PRODUCT/PROCESS CHANGE NOTICE (PCN)

PCN #: N1703-01 Date: May 2, 2017 Product Affected: 8V97053NLGI 8V97053NLGI8 8V97053NLGI/W Date Effective: August 2, 2017	MEANS OF DISTINGUISHING CHANGED DEVICES: <input checked="" type="checkbox"/> Product Mark Prefix character on date code line as shown on Attachment 1 <input type="checkbox"/> Back Mark <input type="checkbox"/> Date Code <input type="checkbox"/> Other
Contact: TSD Clock Team E-mail: clocks@idt.com	Attachment: <input checked="" type="checkbox"/> Yes <input type="checkbox"/> No Samples: Samples are available now.

ATTACHMENT 1 - PCN #: N1703-01

Example of Prefix character change in datecode line

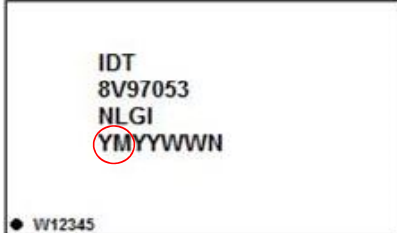
Detail of Change: The change improves device robustness for low temperature operation. On other similar devices, a circuit marginality may on rare occasions cause the device to power up in an undesirable state in low temperature environments. Pro-active measures to implement the same resolution on this device, which uses a similar circuit, have been taken. The failing power-up condition would potentially be seen at cold temperature as for other similar devices even though none has been observed so far. Possible failure modes related to this potential low temperature fault include: no output switching, switching at an incorrect frequency, no access to the registers, and wrong configuration in the digital PLL blocks. While the probability of this fault being manifest in the current design is low, the above mentioned design change will completely eliminate the possibility of this fault occurring.

From: YI	To: YM
 <p>IDT 8V97053 NLGI YIYYWWN</p> <p>● W12345</p>	 <p>IDT 8V97053 NLGI YMYWWN</p> <p>● W12345</p>
